# Access Compliance Report

## Public Rights-of-Way

Intersection ID: 43670	Main Street: S_TRYON_ST	Cross Street: CORSICA_FOREST_DR	Location:	N
ADA ID: 9BA081D34A8A	Ramp Type: Perp	Initial Pass/Fail: Fail	Overall Compliance: No	Severity Score: 25

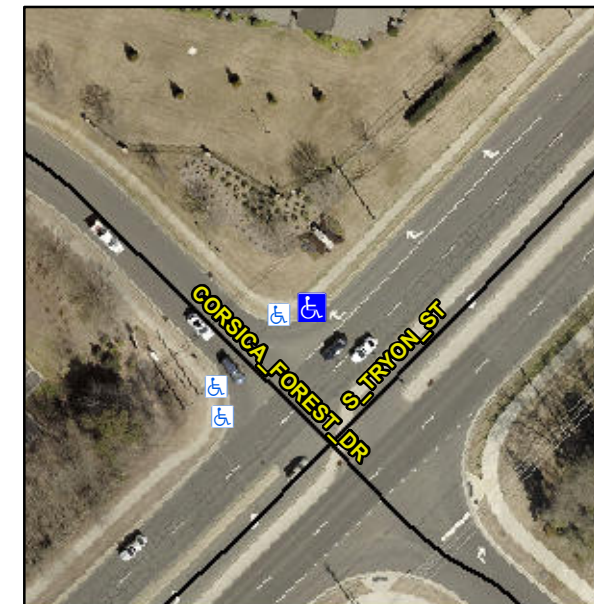
**R304.2.2, R304.5.3**

Compliance	Description	Data	Compliance	Description	Data
N/A	Ramp Length (in)	47.0	No	Ramp Slope (%)	10.2
Yes	Ramp Width (in)	48.0	No	Ramp XSlope (%)	5.4
N/A	Flare Type LT	N/A	N/A	Flare Type RT	N/A
N/A	Flare Slope LT (%)	N/A	N/A	Flare Slope RT (%)	N/A
N/A	Flare Traversable LT?	N/A	N/A	Flare Traversable RT?	N/A
N/A	Landing Length (in)	N/A	N/A	DWS Provided?	N/A
N/A	Landing Width (in)	N/A	N/A	DWS Contrast?	N/A
N/A	Landing Slope (%)	N/A	N/A	DWS Length (in)	N/A
N/A	Landing X Slope (%)	N/A	N/A	DWS Full Width?	N/A
N/A	Landing Curb? (Y/N)	N/A	N/A	DWS Offset (in)	N/A
N/A	Shared Landing?	N/A			
N/A	Gutter Ponding?	N/A	N/A	Gutter Slope (%)	N/A
N/A	Gutter Lip Ht (in)	N/A	N/A	Gutter X Slope (%)	N/A
N/A	Painted X Walk1?	No	N/A	Painted X Walk2?	N/A
	X Walk 1 Direction	To SE		X Walk 2 Direction	N/A
N/A	X Walk 1 Width (in)	N/A	N/A	X Walk 2 Width (in)	N/A
	X Walk 1 Slope (%)	2.0		X Walk 2 Slope (%)	N/A
	X Walk 1 X Slope (%)	4.0		X Walk 2 X Slope (%)	N/A

**Remove & Replace Entire Ramp.**
